REPAIR DOCUMENT

Hopper Bulkhead Upgrade

Repair Document #: **RD-00035**
 Date: August 1, 2012
 Revision: A
 Revision Date: September 6, 2012

Procedure to improve the durability of the model years 2009, 2010, 2011, and 2012 Stoughton Ag Hopper Trailers center divider, which separates the two hoppers.

Figure 3.

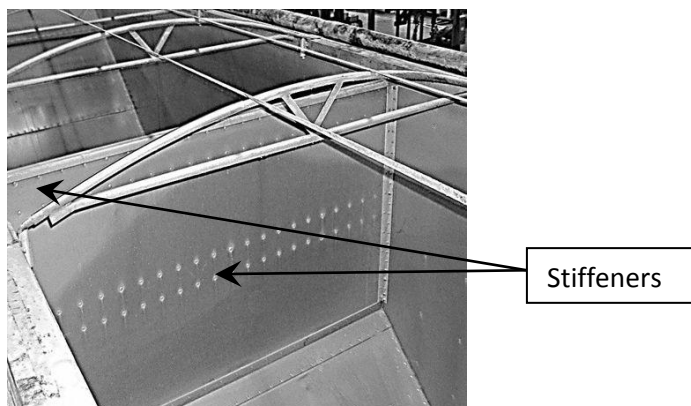
1. Remove fasteners at bulkhead edges next to sidewall, 4 each end, 8 total. Figures 3 and 4.
 - Drill holes out to 5/16, install 5/16 x 1 ¼ bolts and locknuts.
